Access Compliance Report

Public Rights-of-Way

Intersection ID: 11567	Main Street: SHAMROCK_DR	Cross Street: TIPPERARY_PL	Location: NE
ADA ID: BA5A95ADB1BD	Ramp Type: PerpDiag	Initial Pass/Fail: Fail	Overall Compliance: No
			Severity Score: 13.75

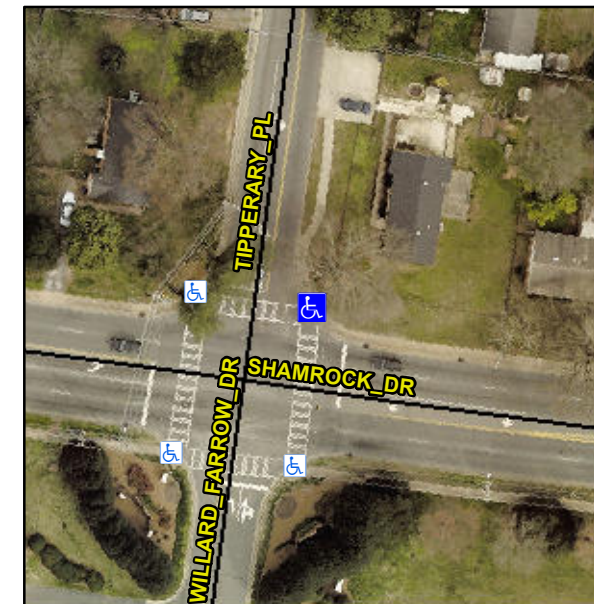
Not Found, R304.2.2, R304.5.3

Compliance	Description	Data	Compliance	Description	Data
N/A	Ramp Length (in)	59.0	No	Ramp Slope (%)	10.2
Yes	Ramp Width (in)	48.0	No	Ramp XSlope (%)	4.6
N/A	Flare Type LT	N/A	N/A	Flare Type RT	N/A
N/A	Flare Slope LT (%)	N/A	N/A	Flare Slope RT (%)	N/A
N/A	Flare Traversable LT?	N/A	N/A	Flare Traversable RT?	N/A
N/A	Landing Length (in)	N/A	N/A	DWS Provided?	N/A
N/A	Landing Width (in)	N/A	N/A	DWS Contrast?	N/A
N/A	Landing Slope (%)	N/A	N/A	DWS Length (in)	N/A
N/A	Landing X Slope (%)	N/A	N/A	DWS Full Width?	N/A
N/A	Landing Curb? (Y/N)	N/A	N/A	DWS Offset (in)	N/A
N/A	Shared Landing?	N/A			
N/A	Gutter Ponding?	N/A	N/A	Gutter Slope (%)	N/A
N/A	Gutter Lip Ht (in)	1.0	N/A	Gutter X Slope (%)	N/A
N/A	Painted X Walk1?	Yes	N/A	Painted X Walk2?	Yes
	X Walk 1 Direction	To W		X Walk 2 Direction	To S
N/A	X Walk 1 Width (in)	100.0	N/A	X Walk 2 Width (in)	102.0
	X Walk 1 Slope (%)	0.1		X Walk 2 Slope (%)	4.2
	X Walk 1 X Slope (%)	2.2		X Walk 2 X Slope (%)	1.0

Remove & Replace Curb Ramp With Two New Directional Ramps or Equivalent.
